Harmonized SAE Foot/Ankle

78051-653-H and 78051-654-H

Publication Date: February 2017

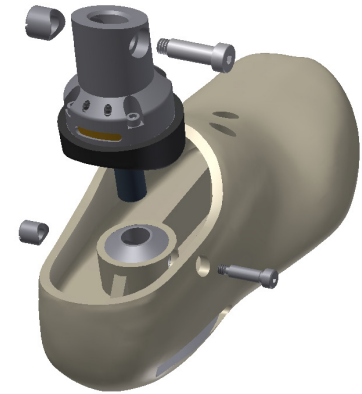
The new ankle adds rubber wrap all around the ball retainer and clamping nuts to the ankle shaft and lower tibia attachments. SAE's full report on the updated ankle design is documented in J2949.

One of the plasticizer components of the FTSS brand vinyl has become obsolete because of environmental concerns, making it necessary to introduce an improved harmonized vinyl. The brown harmonized vinyl agreed upon by the Task Group will be utilized in the harmonized version of the SAE foot. Performance characteristics of the foot are not affected.
